Determination 2009/12

The code-compliance of timber barriers to a deck, stair and pool at 14 Rawhitiroa Road, Kohimarama, Auckland

Figure 1: The as-built barrier to the lower-level terrace

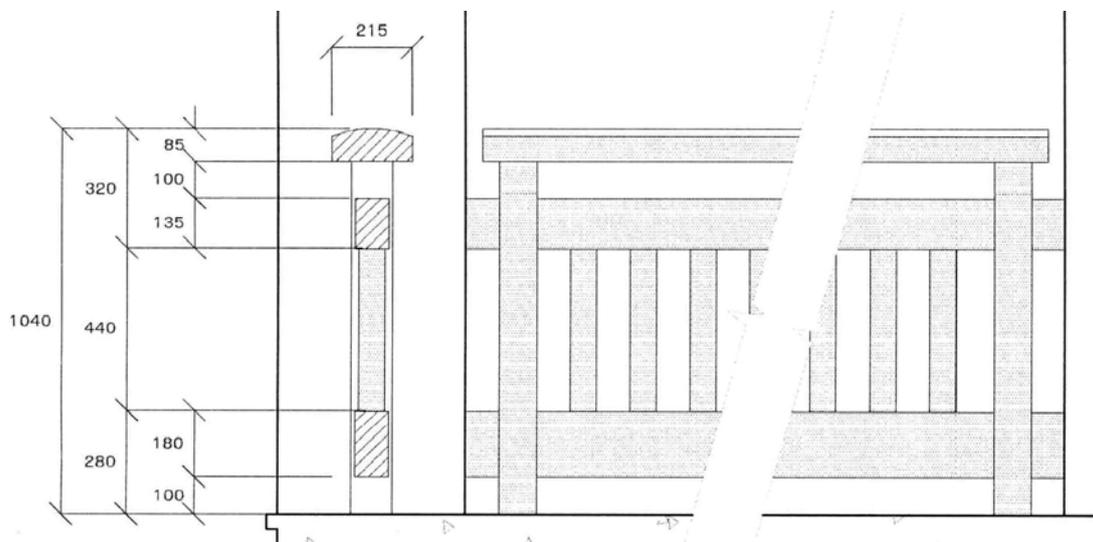
- 7.1.1 The as-built barrier is similar to that shown Figure 1(a) of F4/AS1, which is listed as being suitable for areas frequented by children less than 6 years of age. In comparing the Figure 1 with Figure 1(a) the following is noted:

Figure 1(a) of F4/AS1	The as-built barrier (refer Figure 1 herein)
Height (from Table 1) is 1000mm	Height is 1040mm
The top of the bottom rail is 150mm above the floor	The top of the bottom rail is 280mm above the floor
The distance between the top of the bottom rail and the top of the next rail above is 610mm.	The distance between the top of the bottom rail and the top of the next rail above is 575mm
Size of the top member is not indicated	The top rail is relatively wide at 215mm
Contains no openings that a 100mm diameter sphere could pass through	Maximum opening is 90mm wide

- 7.1.3 A barrier with a 200mm wide top rail was tested and it proved more difficult to climb than a similar barrier with a 50mm wide top rail. Consequently, the 215mm wide profiled top rail on the installed barriers, with a minimum edge thickness of about 75mm makes the barrier more difficult to climb than if it had, say, a 30mm diameter metal top rail that a child could easily grasp. As noted by the architect, the shape of the top rail means that a child will need to reach over to the outside to obtain a grip. The distance from the outside edge of the top rail to the top of the bottom rail equates to the same dimension on the Figure 1(a) barrier if that barrier had a 30 diameter top rail. In addition, the thick sections of all the members of the installed barriers would tend to make the barrier less attractive for climbing for small children because they are not easily grasped by a small hand.

- 7.1.4 Consequently, taking the features and dimensions of the installed barriers into account, I am of the view that the barriers would be as difficult for small children to climb as a Figure 1(a) barrier. I am therefore of the view that the installed barriers would comply with Building Code Clause F4.3.4(g). I also accept that the barriers comply with all the other relevant sub-clauses of Clause F4.3.4.

Figure 2: The as-built barrier to the stairs

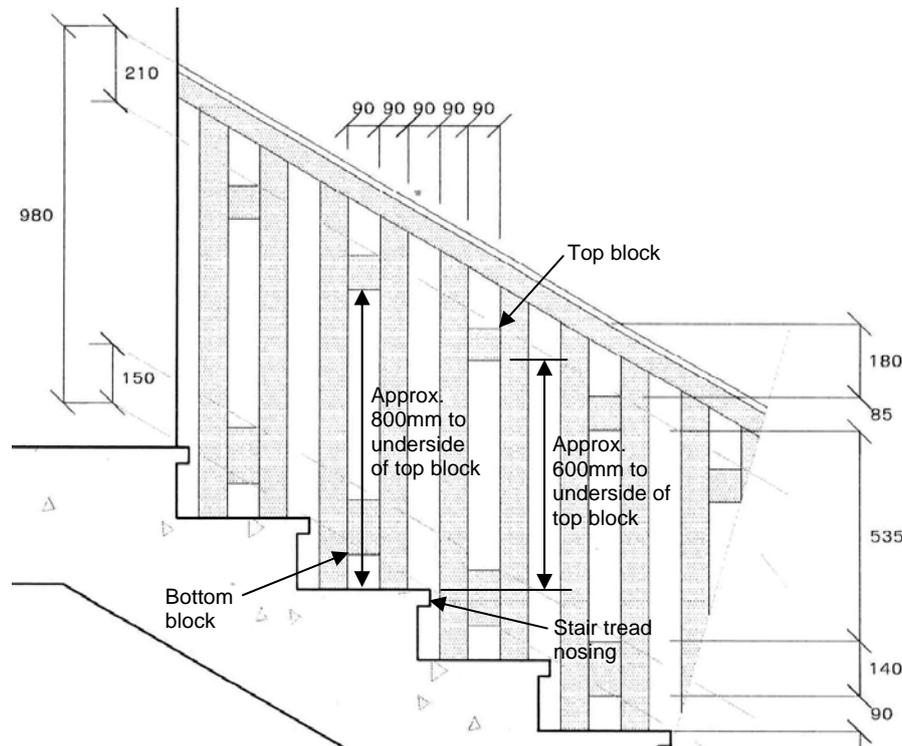
Figure 4 of F4/AS1	The as-built stair barriers (refer Figure 2 herein)
Minimum height requirement is 900mm	Height is 980mm
The distance between the top of the bottom rail and the top of the next rail above is 610mm.	The distance between the top of the bottom rail and the top of the next rail above is 620mm
Rail spacing to be 100mm maximum	Gap between baluster spacings is 90mm
Size of the top member is not indicated	The top rail is relatively wide at 215mm
Contains no openings below the bottom rail that a 150mm diameter sphere could pass through	Maximum opening is 90mm wide

7.2.3 Based on the above comparisons and with the exception of the requirements of Clause F4.3.3, I accept that that the stair barrier complies with Clause F4.

7.3.3 However, as the stair barrier is less than 1.2 metres above the exterior ground level, I do not accept that the barrier complies with the requirements of Clause 1 of the Schedule. Nor, as the underside of the upper blocks are only 800mm above the stair tread (only 535mm between upper and lower blocks), does it comply with Clause 5A of the Schedule, which requires at least 900mm between horizontal supports. In addition, the lower set of blocks between the balusters affords toeholds that would assist children under the age of 6 to climb the barrier.

7.3.4 I am of the opinion that if the 900mm distance set out in Clause 5A is achieved, this will offset the 1.2 metre height requirement of Clause 1. In this case there are blocks in front of, and behind, each stair tread nosing (refer to Figure 2 herein). If the lower blocks only are removed then the distance between the stair tread nosing and the underside of the upper blocks behind the stair tread nosing becomes approximately

800mm, and the distance between the stair tread nosing and the underside of the upper blocks in front of the stair tread nosing becomes approximately 600mm.

- 7.3.5 If all blocks are removed the last dimension is exceeds 900mm which satisfies Clause 5A. This combined with the wide handrail (refer paragraph 7.1.3) with the gripping distance of the 215mm wide top rail taken into account, would give an extended gripping distance. I am of the opinion that, as this distance can be used as an acceptable comparison with the criterion set out in Clauses 1 and 5A, the stair barrier will meet the requirements of Clause 5A. The barrier would therefore comply with the requirements of the Building Code as an alternative solution.

- 8.1 I suggest that the authority issues a notice to fix that requires the owner to bring the stair barrier into compliance with the Schedule. The notice should identify the remedial work set out in paragraph 7.3.4. It is important to note that the Building Code allows for more than one method of achieving compliance.
